CITY OF GLENDALE, CA

DESIGN REVIEW STAFF REPORT - SINGLE FAMILY

October 8, 2022 5105 Finehill Avenue

PDR 2209593 Harut Nazaryan

Contents
-SITE PLAN

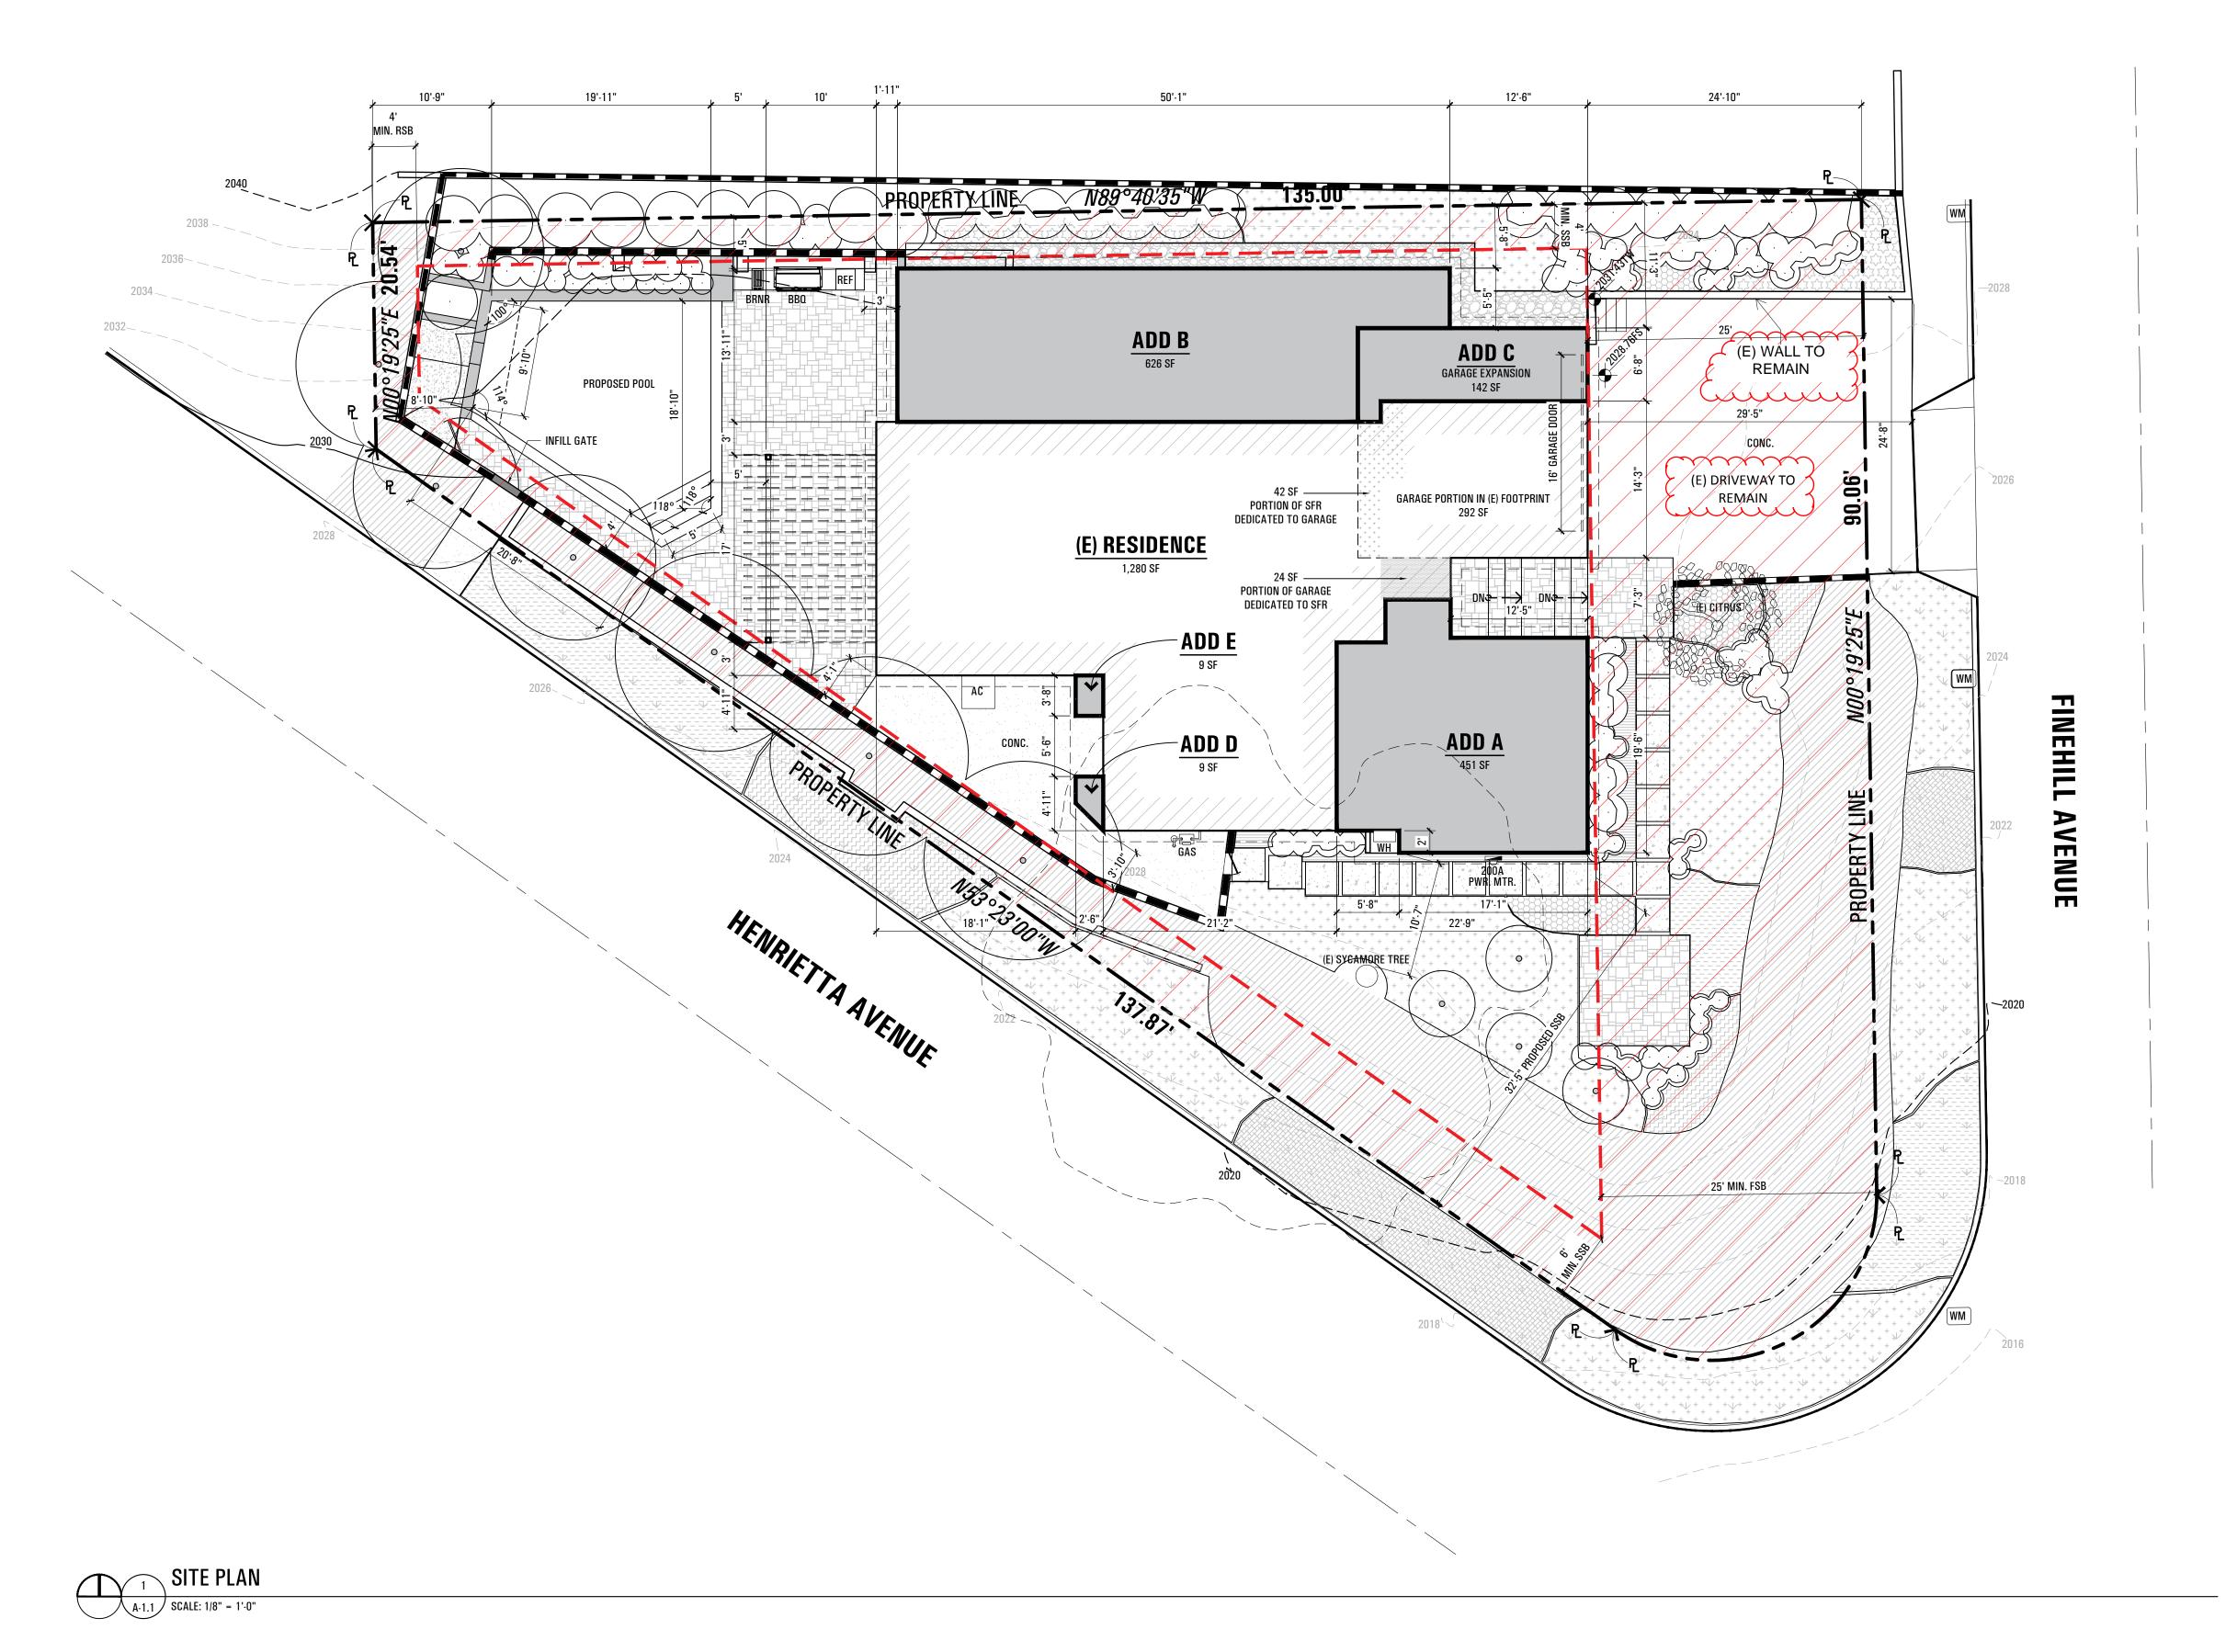
A single protected indigenous sycamore tree is on or within 20 feet of the subject property and is proposed to remain. The City's Urban Forester had visited the subject property, reviewed the project plans and arborist report, and does not anticipate negative impacts to this tree. A condition of approval is included calling for the applicant to obtain an indigenous tree permit prior to issuance of a building permit to ensure adequate tree protection measures are implemented.

Prior to approval of a building permit, an Indigenous Tree Ordinance (ITO) permit is required to incorporate mitigation and tree protection measures that are to the satisfaction of the City's Urban Forester to preserve the existing sycamore tree. Walls and Fences ⊠ yes □ n/a □ no If "no" select from below and explain: ☐ Appropriate style/color/material ☐ Perimeter walls treated at both sides ☐ Retaining walls minimized ☐ Appropriately sized and located The subject property is configured with nonconforming sandstone-colored concrete block walls located within the required six foot street side setback and retaining walls throughout property that are proposed to remain. If these walls are demolished, the replacement walls must comply with current Zoning Code development requirements, as well as design standards. **Determination of Compatibility: Site Planning** The proposed site planning is appropriate, as modified by any proposed conditions, to the site and its surroundings for the following reasons: The additions are configured with code-compliant setbacks along the street front, street side and interior yards, and continue the setback patterns from Henrietta Avenue and Finehill Avenue. The project's additions will be primarily sited on flat portions on the lot. However, portions of the bedroom and garage additions at the north(side) facade require approximately 38 cubic yards of grading (all export) to allow the building to be set into the slope. New landscaping will be provided throughout the property with a variety of low- or very-low water use landscaping. Prior to approval of a building permit, an Indigenous Tree Ordinance (ITO) permit is required to incorporate mitigation and tree protection measures that are to the satisfaction of the City's Urban Forester to preserve and protect the existing sycamore tree. Massing and Scale Are the following items satisfactory and compatible with the project site and surrounding area? **Building Relates to its Surrounding Context** ⊠ yes □ n/a □ no If "no" select from below and explain: ☐ Appropriate proportions and transitions ☐ Relates to predominant pattern ☐ Impact of larger building minimized **Building Relates to Existing Topography** If "no" select from below and explain: ☐ Form and profile follow topography ☐ Alteration of existing land form minimized ☐ Retaining walls terrace with slope The project addition's will be mainly sited on previously graded flat portions of the lot with portions of the bedroom and garage additions will be set into the northern slope to allow the profile the building follow the topography of the site. **Consistent Architectural Concept**

- 1. Obtain an Indigenous Tree Ordinance (ITO) permit to incorporate mitigation and tree protection measures that are to the satisfaction of the City's Urban Forester to preserve the existing sycamore tree prior to any approval of a building permit.
- 2. Revise the submittal package to indicate that the number of window operation types will be limited, that all windows will be recessed into the wall and feature wood sills, and that detail drawings are provided to show what frame type (block or nail-in) will be used at new or existing window openings. The revisions must be reviewed and approved by Planning staff prior to issuance of a building permit.

-EXISTING EAST & WEST ELEVATION -PROPOSED EAST & WEST ELEVATION

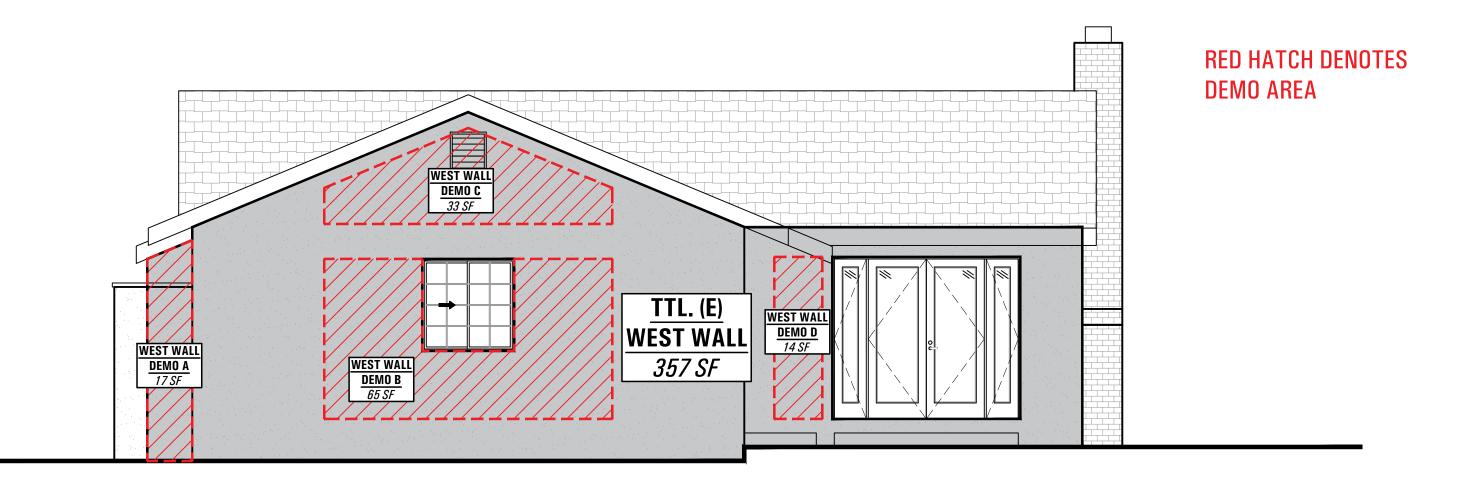
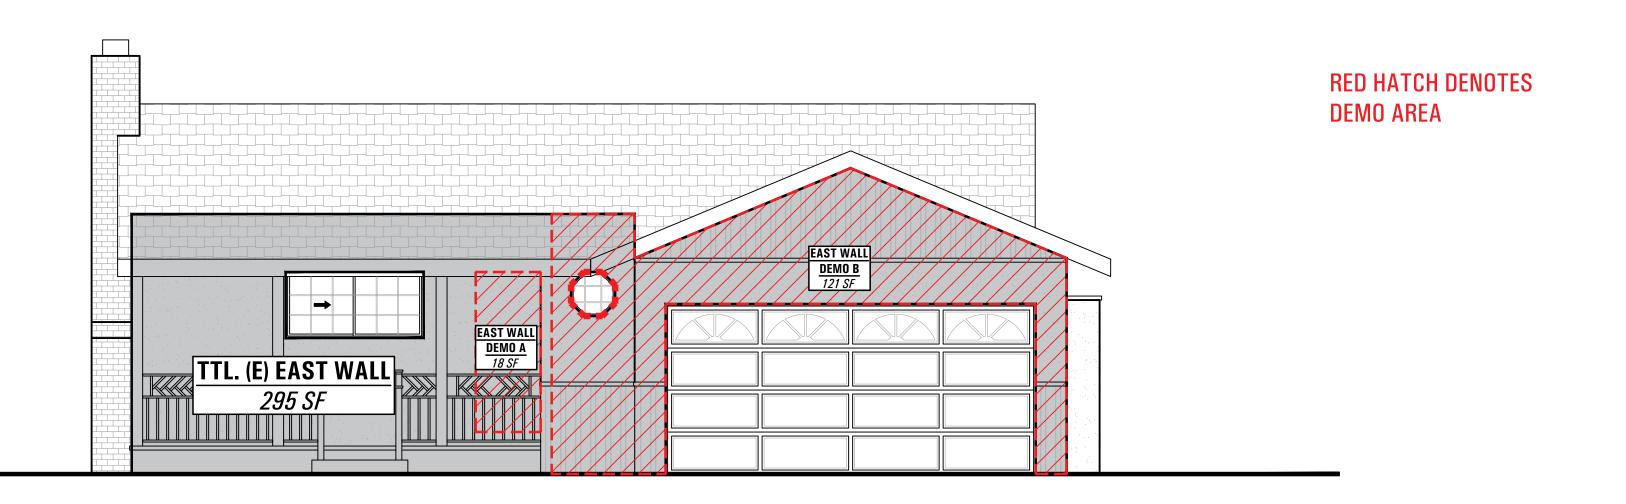
casement, awning, fixed and sliding, will be provided throughout the house. However, the proposed elevations and vertical window sections demonstrate that these windows will have block frames recessed into the walls. A condition of approval has been added that all new windows visible from the street shall have a recessed placement and that the number of different operation types be limited. The drawings must also be clarified and revised prior to Building & Safety plan check submittal to indicate if different construction techniques will be employed at existing versus new window openings. Privacy □ yes ⊠ n/a □ no If "no" select from below and explain: ☐ Consideration of views from "public" rooms and balconies/decks ☐ Avoid windows facing adjacent windows Finish Materials and Color ⊠ yes □ n/a □ no If "no" select from below and explain: ☐ Textures and colors reinforce design ☐ High-quality, especially facing the street ☐ Respect articulation and façade hierarchy ☐ Wrap corners and terminate appropriately **Paving Materials** □ yes ⊠ n/a □ no If "no" select from below and explain: ☐ Decorative material at entries/driveways ☐ Permeable paving when possible ☐ Material and color related to design Lighting, Equipment, Trash, and Drainage ⊠ yes □ n/a □ no If "no" select from below and explain: ☐ Light fixtures appropriately located/avoid spillover and over-lit facades ☐ Light fixture design appropriate to project ☐ Equipment screened and well located ☐ Trash storage out of public view ☐ Downspouts appropriately located ☐ Vents, utility connections integrated with design, avoid primary facades **Ancillary Structures** ⊠ n/a □ no □ yes If "no" select from below and explain:

The window schedule indicates that vinyl nail-on windows, with a variety of operations such as
